TO:	Fairfax Planning Commission
DATE:	September 15, 2016
FROM:	Jim Moore, Director of Planning and Building Services Michelle Levenson, Zoning Technician
LOCATION:	145 Forrest Avenue; Assessor' Parcel No. 002-192-38
ZONING:	Residential RS 6 Zone
PROJECT:	Renovate and Expand (112 square feet) a Single-Family Residence
ACTION:	Application No. 16-35; Conditional Use Permit
APPLICANT:	Erick Mikiten, Mikiten Architecture
OWNER:	Vakil Kuner
CEQA STATUS:	Categorically Exempt, § 15301(a)

RESOLUTION NO. 16-28

A Resolution of the Fairfax Planning Commission Approving a Conditional Use Permit for the Expansion of the Residence at 145 Forrest Avenue

Re: 145 Forrest Avenue, Fairfax, Marin County
Assessor Parcel Number 002-192-38
Preliminary Plan Review

Photo 2: Compromised base of wall. Note exposed open-ended drainage pipe.

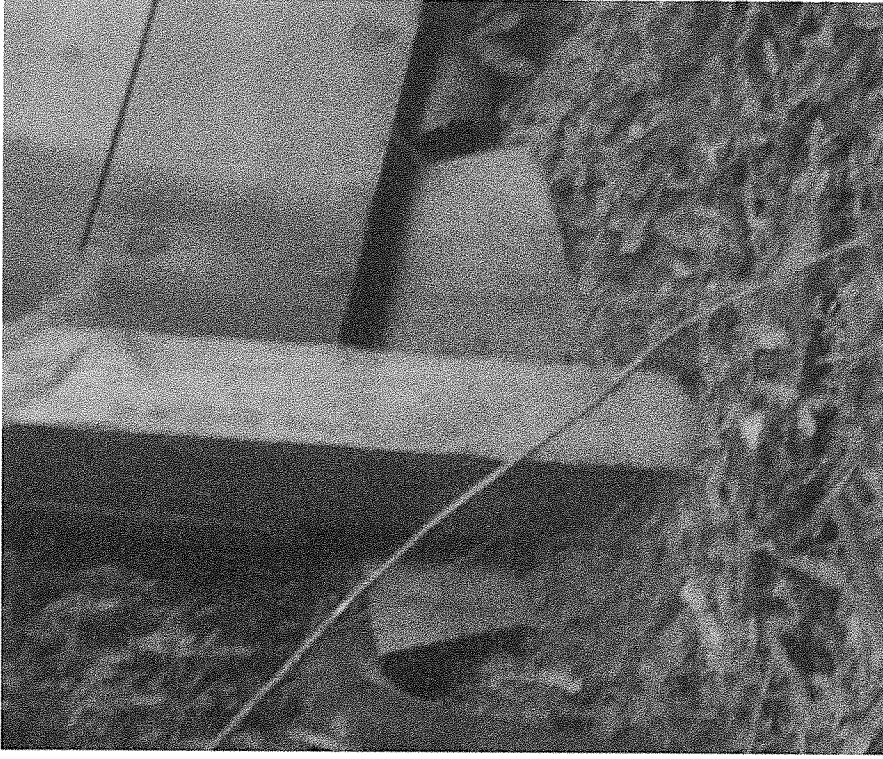
The wall extension appears to be un-engineered and is attached to several mature redwood trees, endangering the health of the trees and posing potential safety issues to the roadway below. (Attachment C). In a letter dated January 25, 2016 (Attachment D), staff requested additional information regarding the proposed retaining wall repairs including a report by an arborist detailing the present and continued health of the redwood trees.

Therefore, staff recommends that the Planning Commission require as a "Condition of Approval" of the project that all discretionary approvals and a building permit for the retaining wall repair and legalization be obtained, prior to, or in conjunction with, the issuance of the building permit for the single-family residence improvements. With implementation of this "Condition of Approval" as well as the location of the proposed residential improvements outside of required setbacks, the proposed project would not cause adverse physical or economic effects or create undue or excessive burdens in the use and enjoyment of neighboring properties.

A-2.1

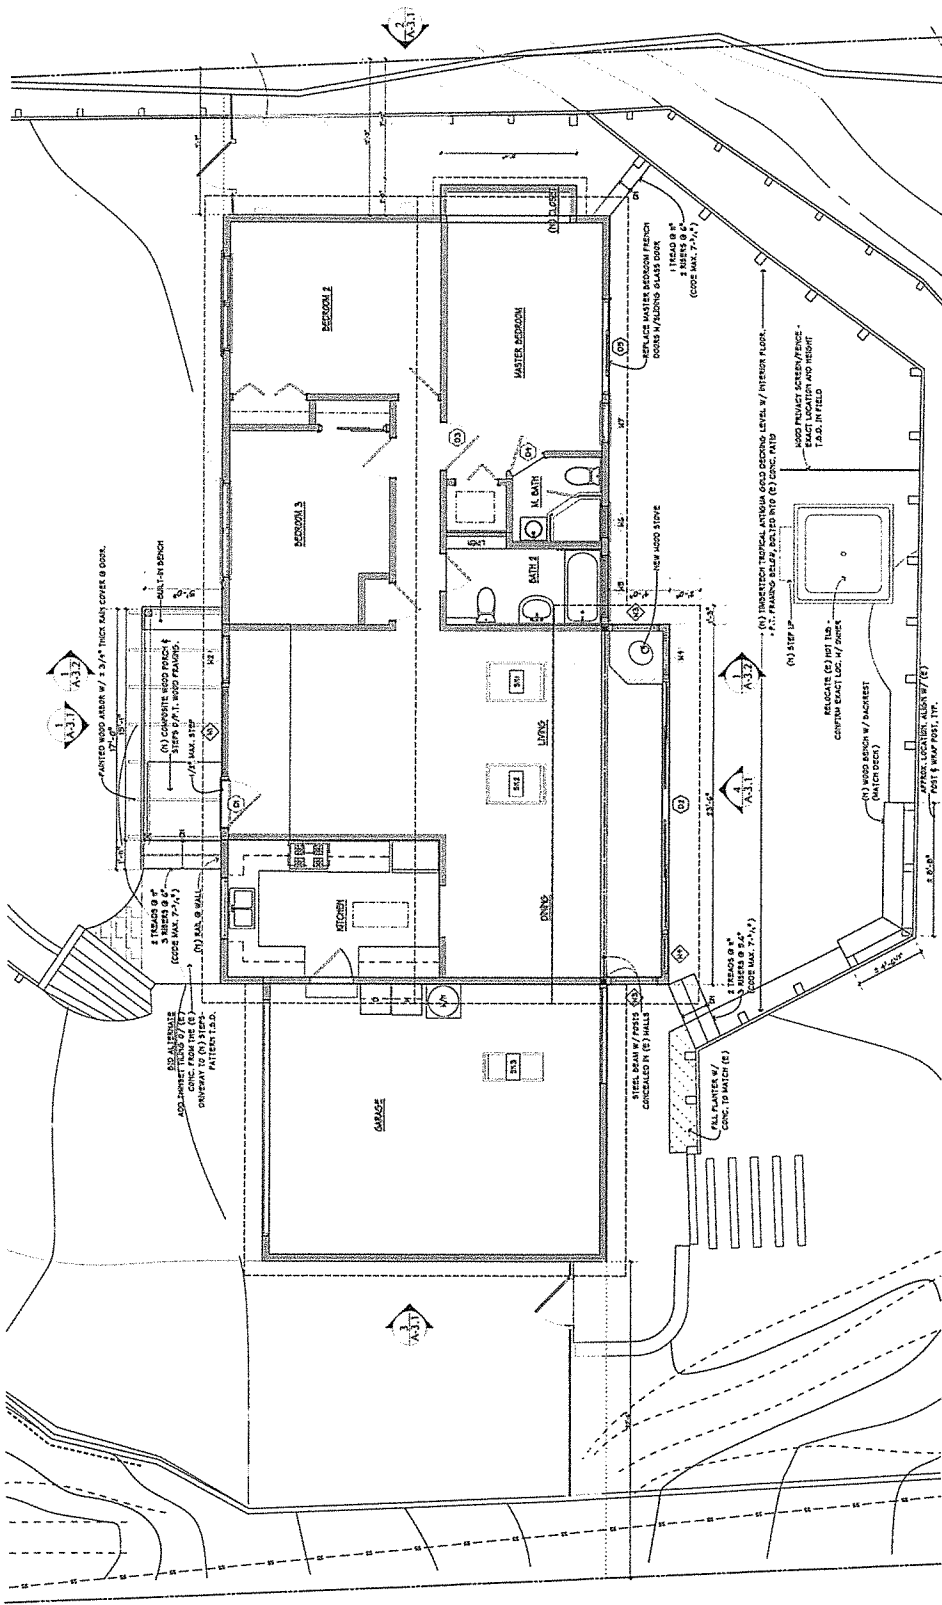
On September 6, 2016, the applicant contacted staff regarding revisions to the project. On September 7, 2016, the applicant submitted revised plans for the project; the most current version of the project omits an enclosed foyer and closet, and instead proposes to provide an exterior porch with an arbor (62 square feet) (Attachment F). The total additional square footage with the current proposal is 112 square feet. All other elements of the project remain unchanged from the June 23, 2016 submittal. The plans showing the most recent version of the project and dated September 6, 2016, are not to scale; please refer to the plans dated June 23, 2016, to determine accurate dimensions.

1. This approval is limited to the development illustrated on the plans prepared by Mikiten Architecture, page T-1.0 (revised 9/6/16), T-2.0 (9/10/15), A-1.0 (revised 9/6/16), A-2.1 (revised 9/6/16), A-3.1 (revised 9/6/16) and A-3.2 (revised 9/6/16).
2. Prior to the issuance of a building permit for the residential improvements, the owner/applicant shall either: (1) include repair of the unpermitted, upper driveway retaining wall in the building permit application for the residential improvements; or (2) submit a separate building permit application for the retaining wall improvements concurrently with the building permit application for the residence.
